# Gunnison County Environmental Health Board Agenda

- 1:15 p.m.** Call to order; determine quorum  
Approval of Minutes from 9-9-2021 meeting  
Unscheduled citizens
- 1:30 p.m.** William and Cynthia Graf, Public Hearing for a variance to the Gunnison County OWTS Regulations for reduced setbacks to a wetland boundary at 21 Glacier Lily Way, Lot 21 Glacier Lily Estates, OWTS-21-00208

Attached is a drawing titled "Graf Residence - O.W.T.S." for the proposed new OWTS located within the Gunnison County Environmental Health District, dated August 24, 2021, which sets forth the details for construction of the system.

**1 SITE PLAN**  
SCALE: 1/16" = 1'-0"

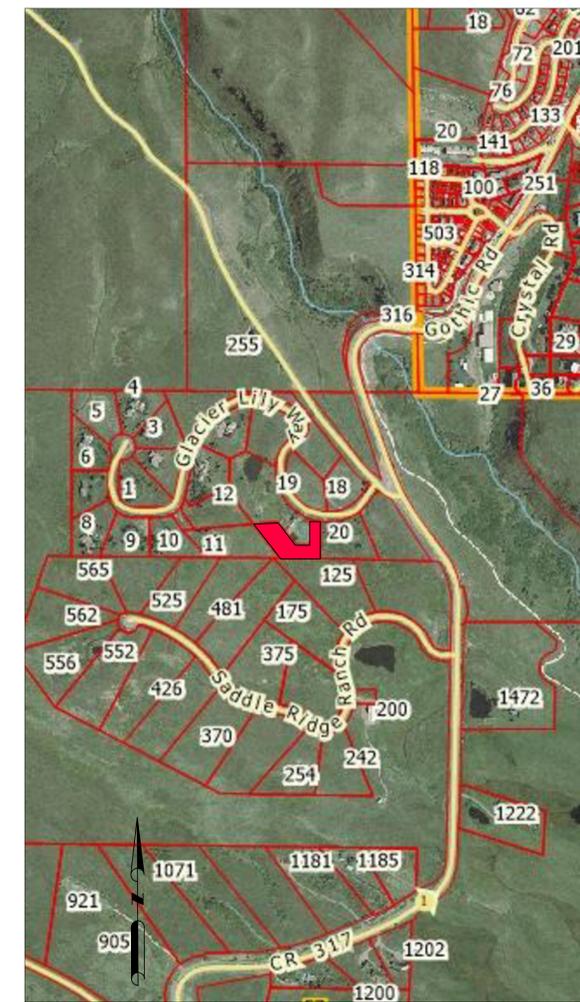
It appears that the proposed development plan and OWTS design utilizes the parcel layout, topography, and physical features as much as possible to provide for the greatest degree of compliance with the Gunnison County OWTS Regulations. The closest proposed setback distance to the wetland boundary is just under 75 feet and does not meet the County requirement for 100 feet, however, the State minimum of 50 feet is met. Staff recommends approval of the Graf application for a variance to the Gunnison County OWTS Regulations, Section 7.D. and Table 7-1, for the proposed design.

- It is the responsibility of the installer to provide, to the Public Health Official, a gradation of the sand media to qualify as a “Secondary” sand media. The gradation date must be dated no more than one month prior to the installation date. However, a gradation of the actual material placed in the excavation is recommended. If this gradation cannot be met the Engineer SHALL be notified as the size of the soil treatment area must be adjusted prior to the installation of any components.
